Water Resources Department

SUBJECT: PERMIT AMENDMENT # 10167

Interoffice Memorandum

To: Water Rights
From: Karl Wozniak
Subject: T-10169

Estimated Hydraulic Interference at MARI 53068 From Proposed Well 3

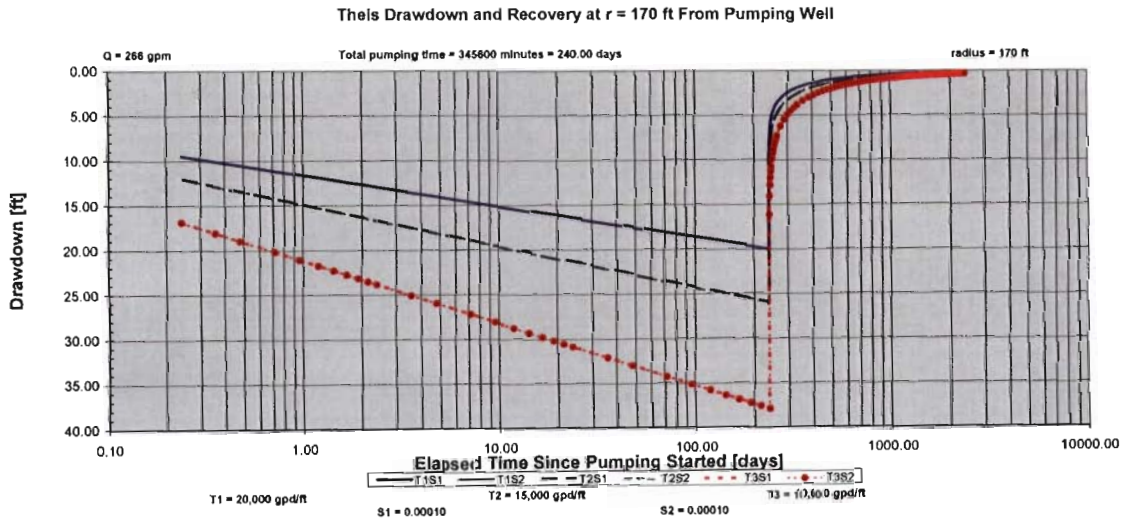
A nearby permitted well, MARI 53068 (permit G- 13440), is located about 170 feet to the east of the applicant's proposed well 3 and about 700 to 900 feet south of proposed wells 4 and 5. The close proximity between proposed well 3 and MARI 53068 suggests that hydraulic interference may be excessive. Therefore, interference at MARI 53068 was estimated using the Theis equation. To determine the maximum potential impact, pumping from proposed well 3 was simulated for 240 days (the length of the irrigation season) using the maximum pumping rate allowed on the permit. An effective transmissivity of 15,000 gpd/ft was estimated using late-time pump test data from a 4-hour test conducted in September 1998 for MARI 53068. Storativity was assumed to be 0.0001, a typical value for confined Columbia River Basalt aquifers. To account for uncertainties, transmissivity was varied by 33% to determine the sensitivity of drawdown to this parameter. Under these conditions, hydraulic interference at MARI 53068 is estimated to be 20 to 38 feet. Interference after 100 days of continuous pumping is estimated to be 18 to 35 feet. Interference would be less if pumping was discontinuous over time or if pumping was distributed between all three proposed wells. These estimates suggest a high probability that pumping from

proposed well 3 will result in greater than 15 feet of hydraulic interference with MARI 53068 over the length of the irrigation season if proposed well 3 is capable of high yields and is used as the primary source on the permit. A condition on the applicant's permit (G-15845) allows only 15 feet of hydraulic interference with a neighboring well. Therefore, it is likely that the transfer will result in injury to an existing right. However, the transfer likely will not result in injury if proposed well 3 is not included in the final order.

The transfer will likely not result in injury to existing rights if proposed well 3 is excluded from the final order.
